STATE OF CONNECTICUT  
CONNECTICUT SITING COUNCIL

In Re: Application of New Cingular Wireless : Docket No. 373  
PCS, LLC (AT&T) for a Certificate of Environmental:  
Compatibility and Public Need for the Construction :  
Maintenance and Operation of a Telecommunications:  
Tower Facility at St. Matthew Lutheran Church at :  
224 Lovely Street in the Town of Avon : March 16, 2009

PRE-HEARING INTERROGATORIES  
DIRECTED TO APPLICANT AT&T BY TOWN OF AVON

**Map Showing  
Huckleberry Open Space  
Foundland  
Pond Ledge**

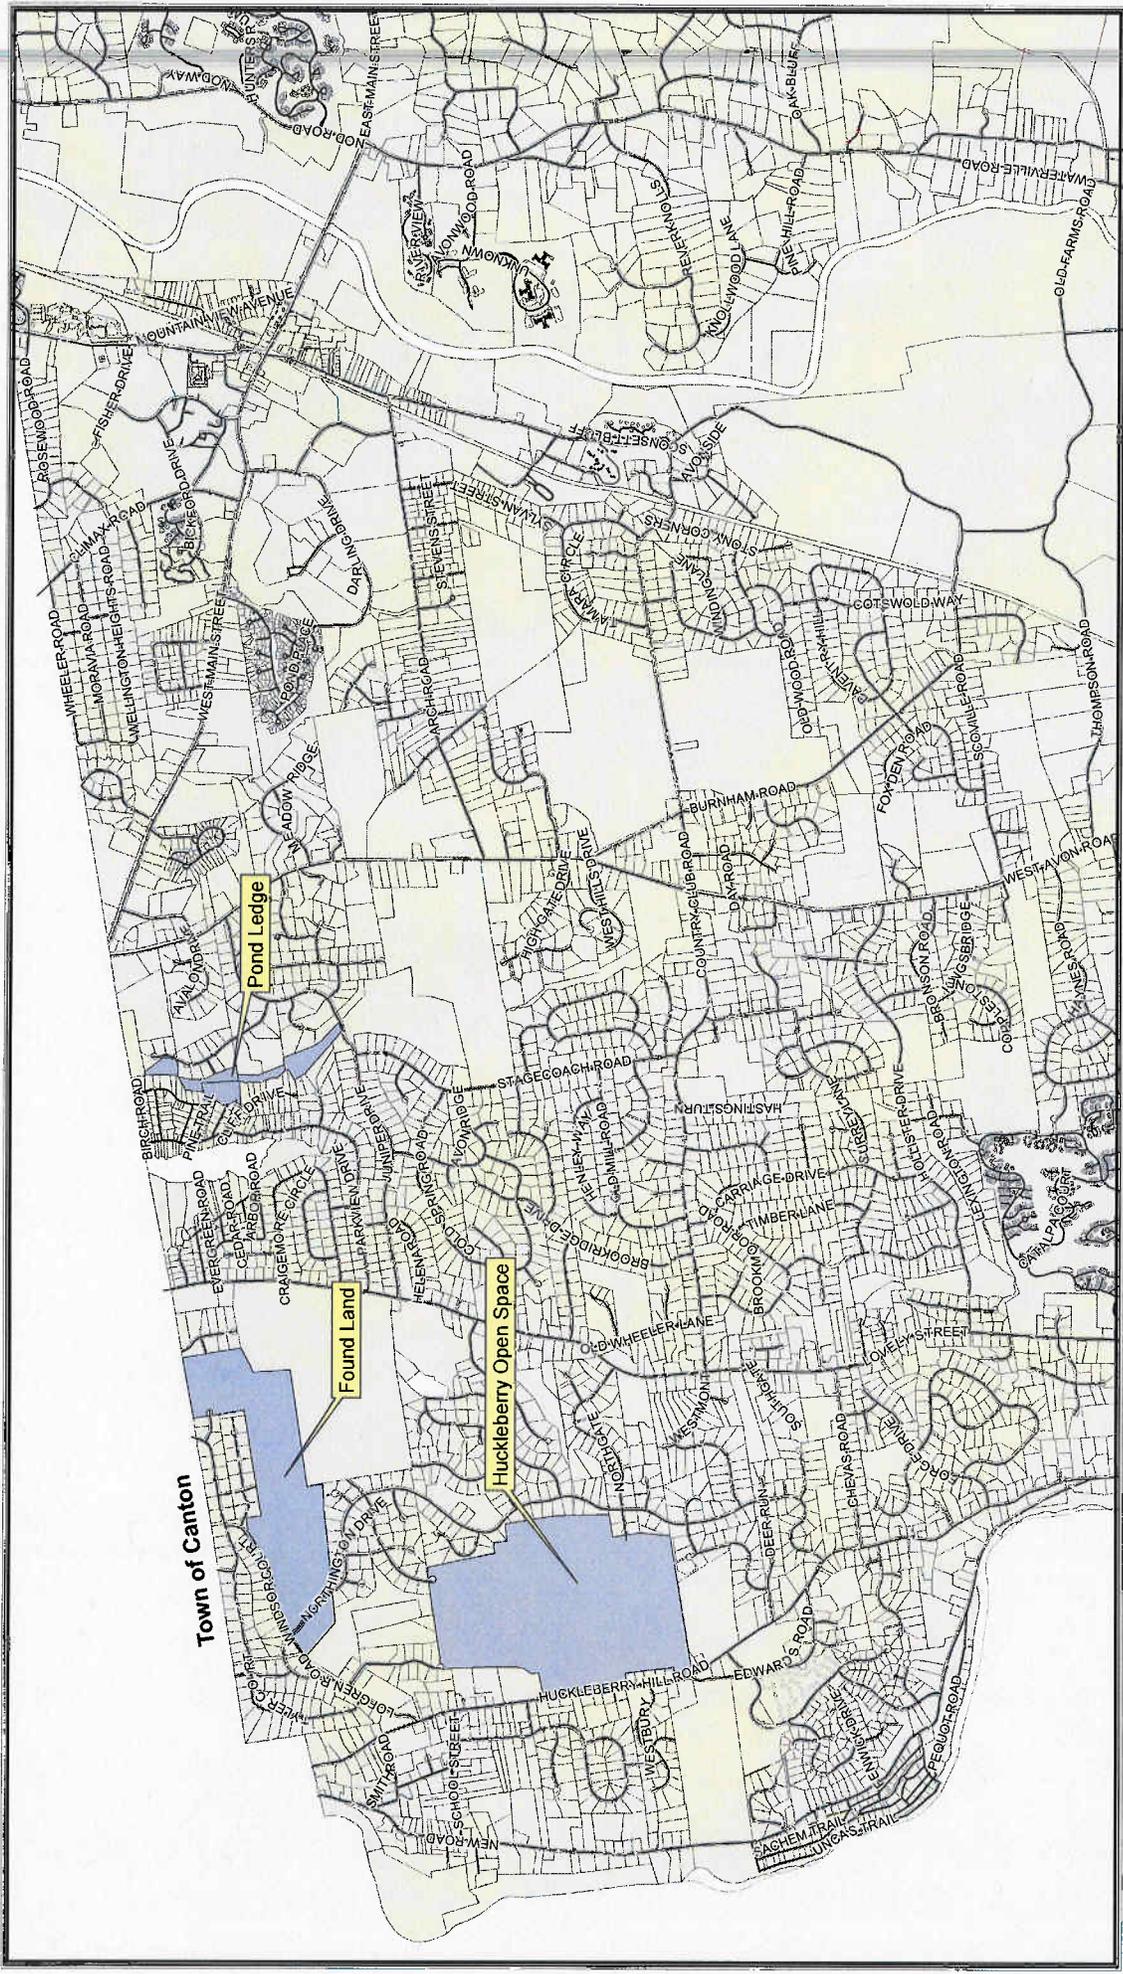
8. Did AT&T consider locating the proposed facility in the Pond Ledge area of Avon, specifically including property owned by Avon Water Company? Refer to Attachment A for reference. Would this location meet AT&T's coverage needs? If answering in the negative, please provide an explanation as to why not.
9. Did AT&T consider Huckleberry Hill in Avon? Refer to Attachment A for reference. Would this location meet AT&T's coverage needs? If answering in the negative, please provide an explanation as to why not.
